Access Compliance Report Public Rights-of-Way (Pedestrian Signals)

Intersection ID: N/A	Main Street:	Cross Street: N/A	Location: N/A
ADA ID: 13EE6086841F	Signal Type: One Push Button-Non APS	Overall Compliance: No	Severity Score: BTN 1: N/A BTN 2: N/A No BTN: N/A
Codes/Mitigation Info/Possible Solution		Field Measurements/Component Compliance

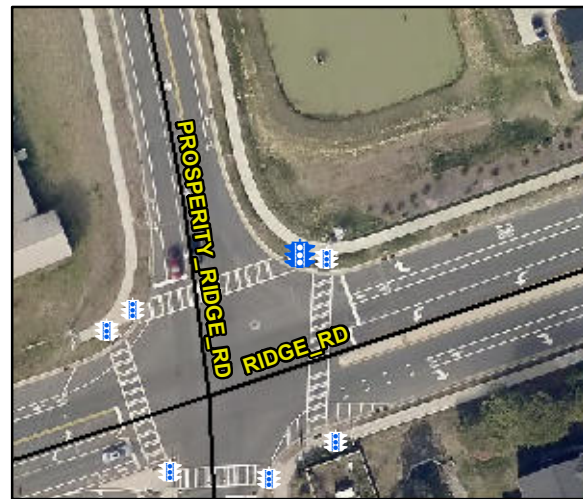
Possible Solutions: Replace Signal Push Button With APS Button on New Post. Remove & Relocate Sign.

PROW/ADA: TMUTCD 4e.08, R404.1, R404.7.3
